Dunoon to Loch Long 132kV OHL Rebuild

Appendix 4.4 – EIA Scoping Opinion

**Scoping Opinion On Behalf Of Scottish Ministers Under The
Electricity Works (Environmental Impact Assessment) (Scotland)
Regulations 2017**

Dunoon to Loch Long 132kV Overhead Line Rebuild
Scottish Hydro Electric Transmission plc

From: radionetworkprotection@bt.com
Sent: 01 June 2022 09:08
To: [REDACTED]
Cc: radionetworkprotection@bt.com
Subject: RE: Dunoon to Loch Long 132kV scoping - additional information WID11857
Attachments: Dunoon EIA Scoping Figure 1.1 Location (3).pdf

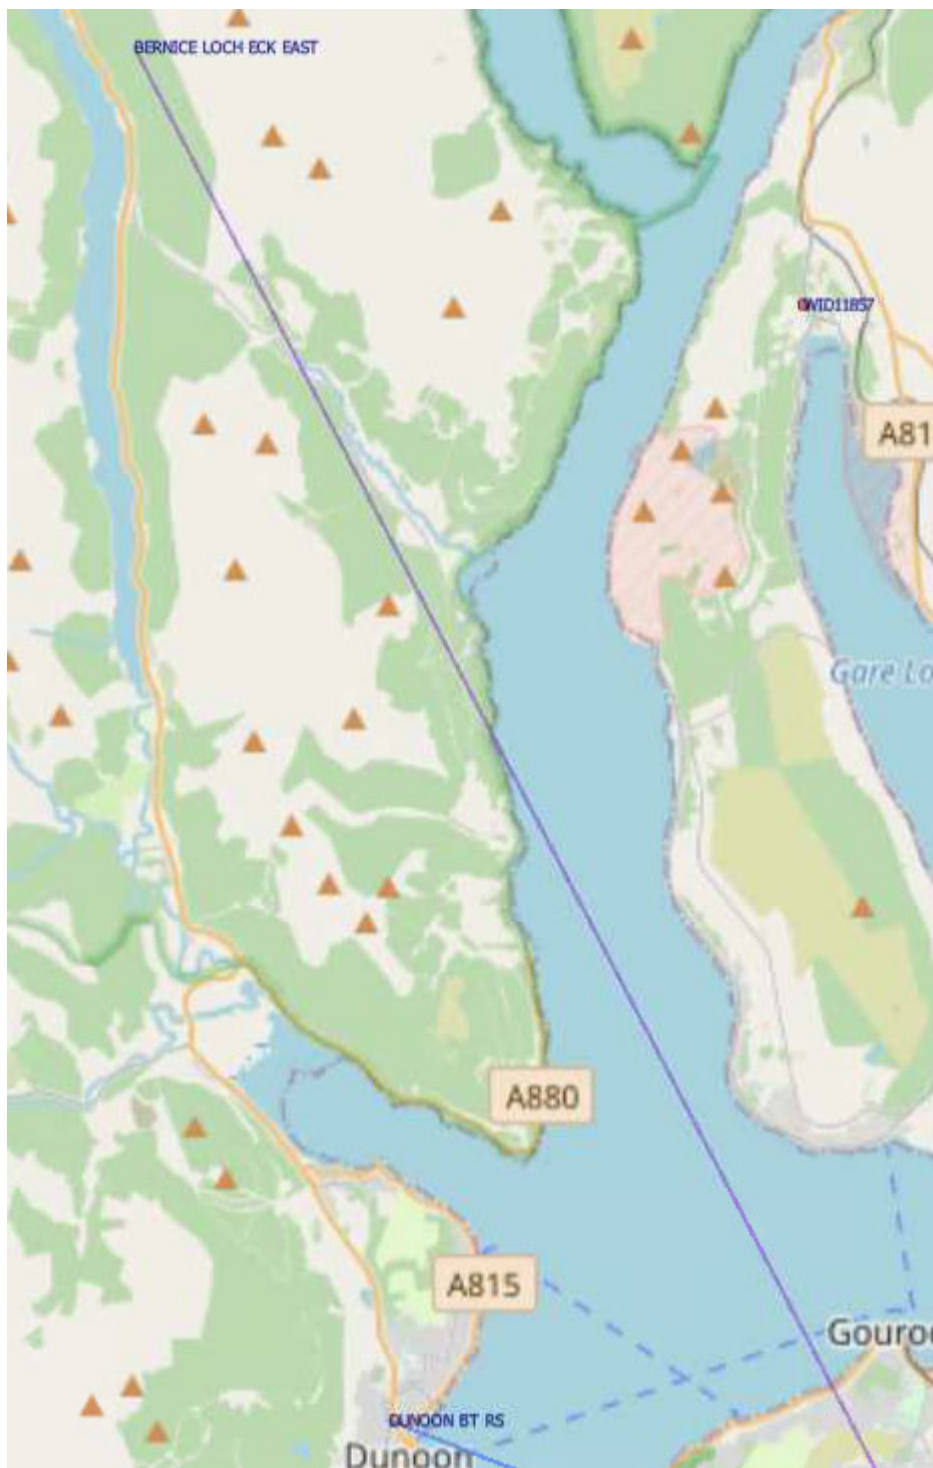
The conclusion is that, the Project indicated should not cause interference to BT's current and presently planned radio network unless the heights of the structures change around the active radio link below (purple line). If there are any structures around the area please that change please send over the new heights and co-ordinates and we will mitigate the results.

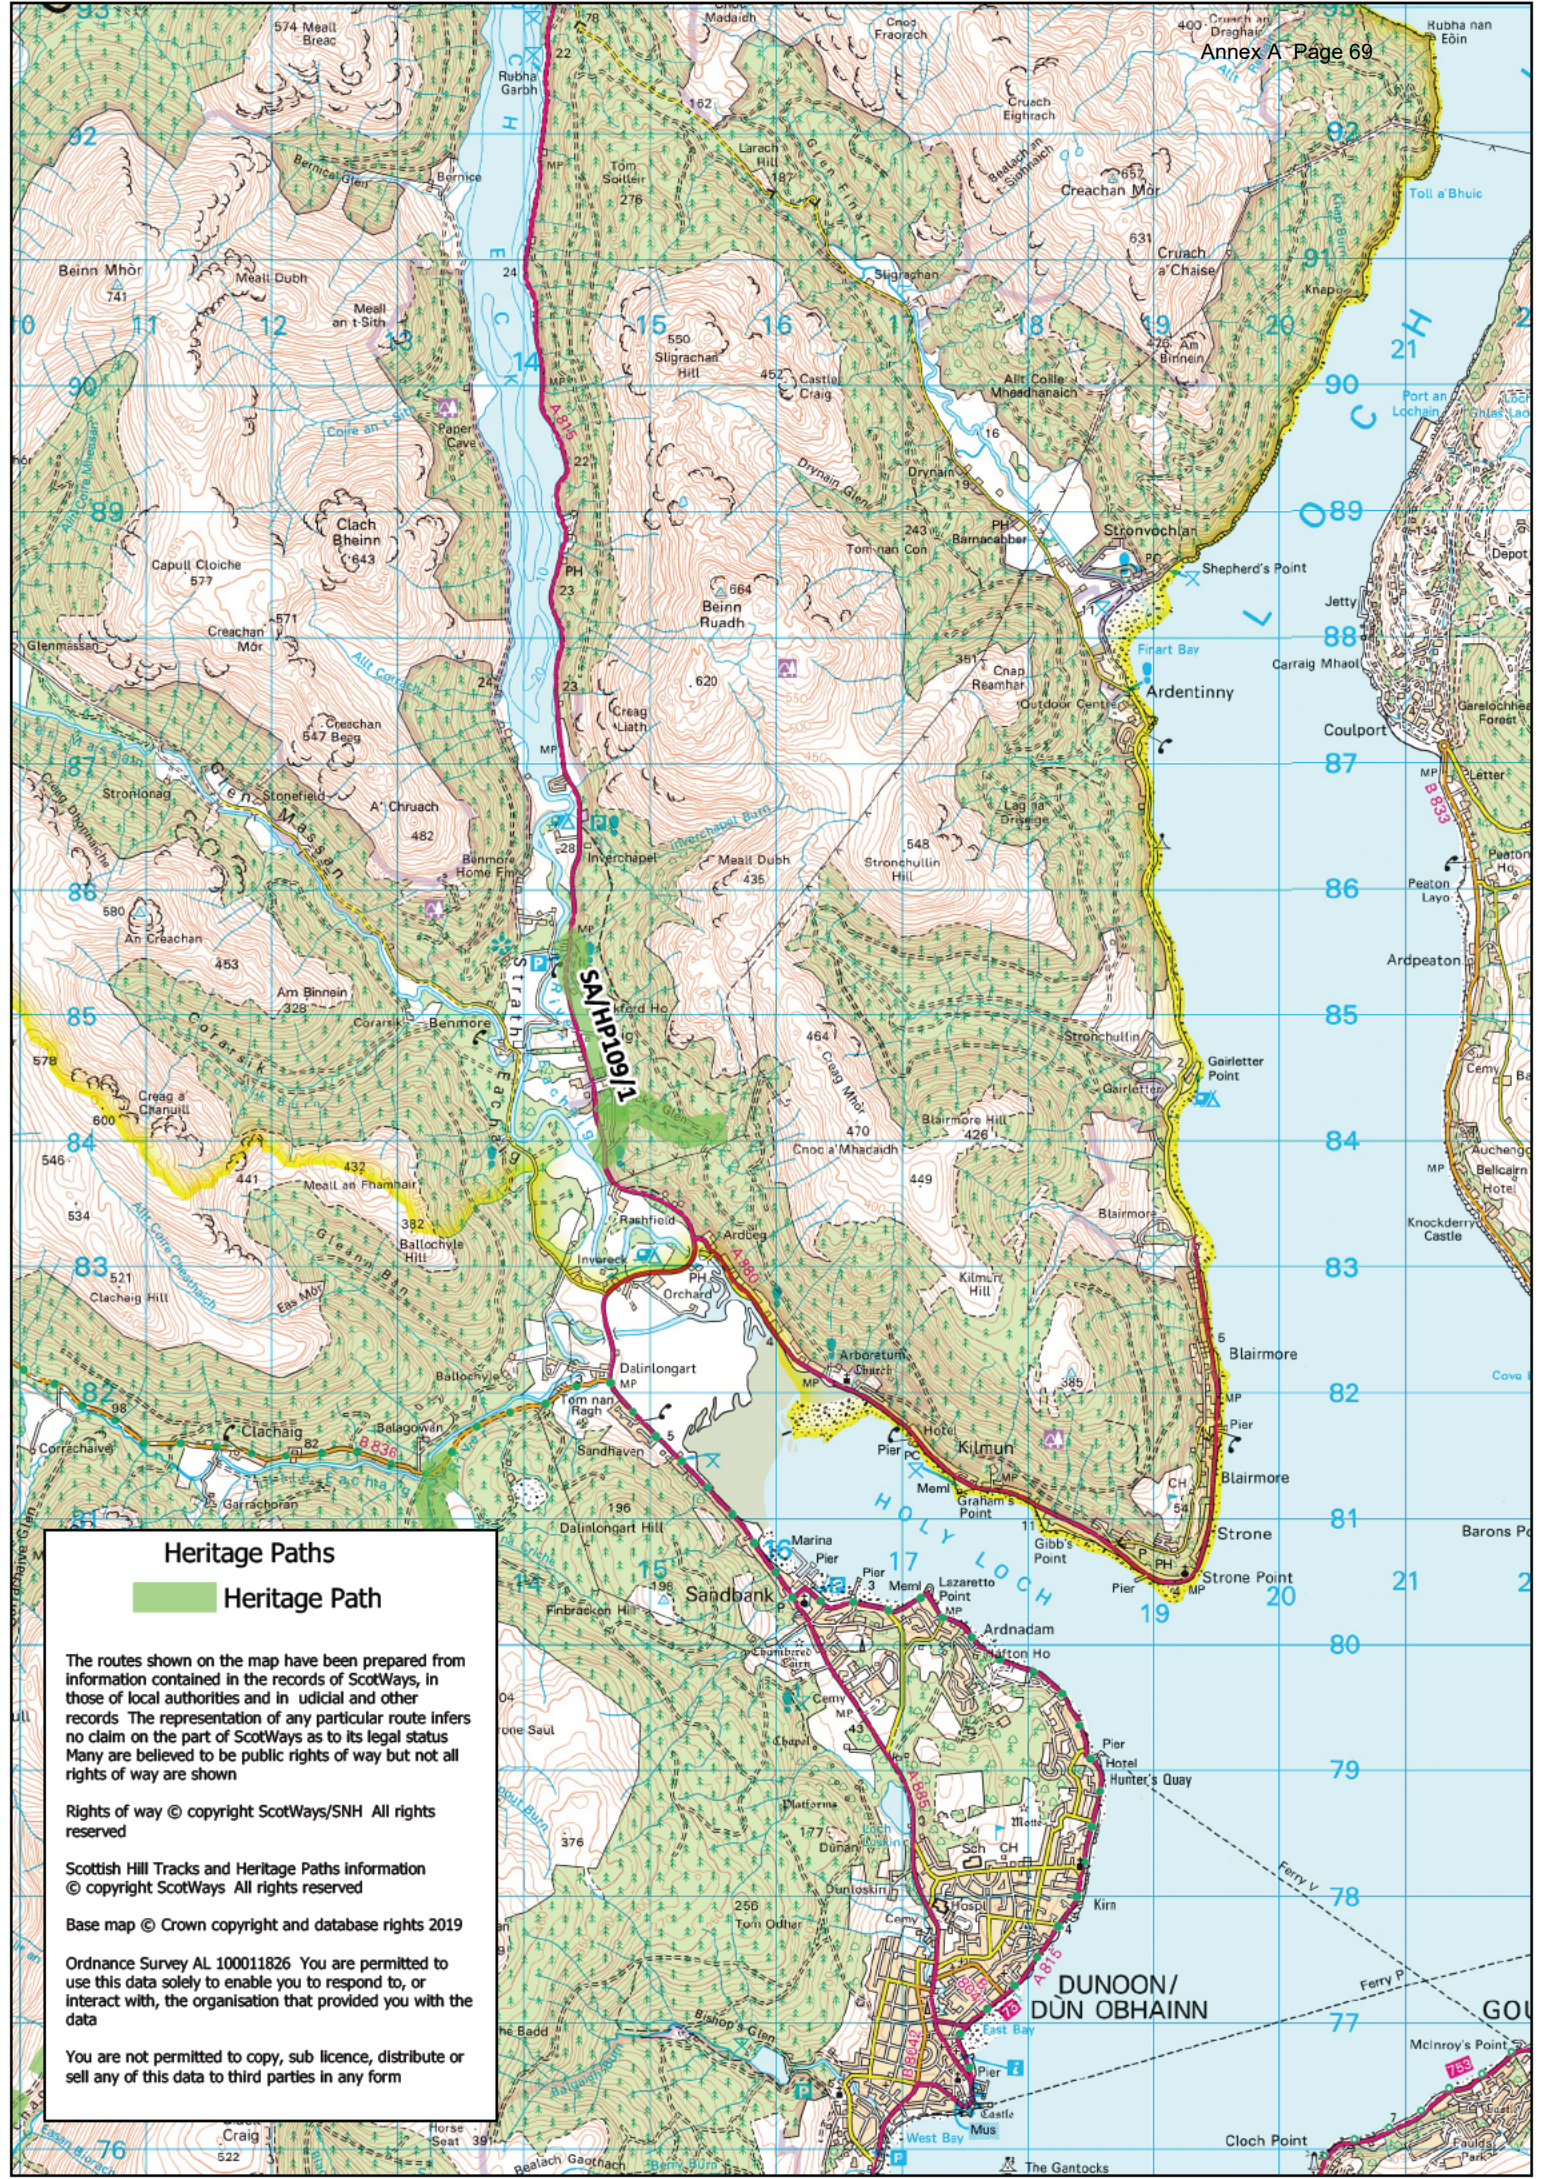
The enclosed map shows the Heritage Paths project promotes routes, *Old Road through Strath Eachaig* [HP109] and *Puck's Glen* [HP110] for their historic interest. These old routes cross or are close to the application site as shown on Figure 2.1 *Overhead Line Route*.

Under section 3 of the Land Reform (Scotland) Act 2003, there is a duty upon landowners to use and manage land responsibly in a way which respects public access rights. Under section 14 of the same Act, access authorities have a duty to uphold access rights. Accordingly, we suggest that the

applicant may wish to approach the relevant authority's access team for their input when drawing up their Access Management Plan for their proposed development.
